Affected : Sailplane model "Kestrel"
F.R.G. Type Certificate No. 276
- all serial numbers -

Subject : Rudder gimbal drive
- rear actuator arm -

TECHNICAL NOTE NO. 401 - 19

301-45-13

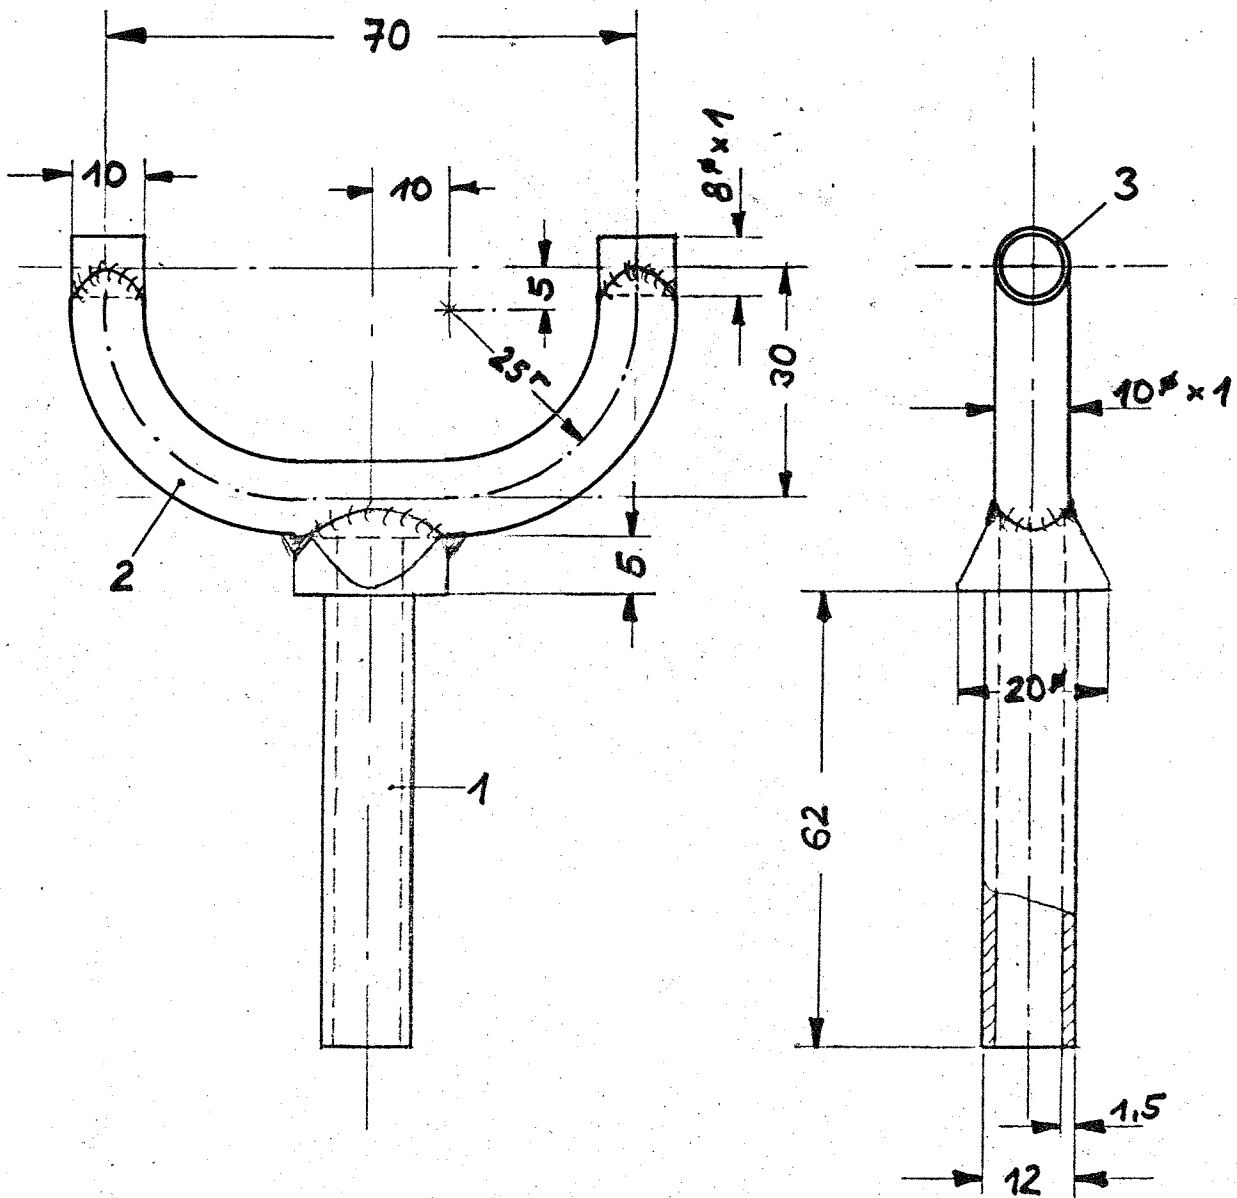
Reason : Failure of the actuator arm caused by loads applied
when regularly lifting the fuselage by its rudder.
and/or when fuselage has broken.

Actions : The faulty part, made according to drawing No. 301-45-10,
must be replaced by an improved actuator arm, made in
accordance with drawing No. 301-45-13.

1 off rudder actuator arm made according to drawing No. 301-45 - 13

Only genuine parts made in accordance with drawing No. 301-45-13 must be used.
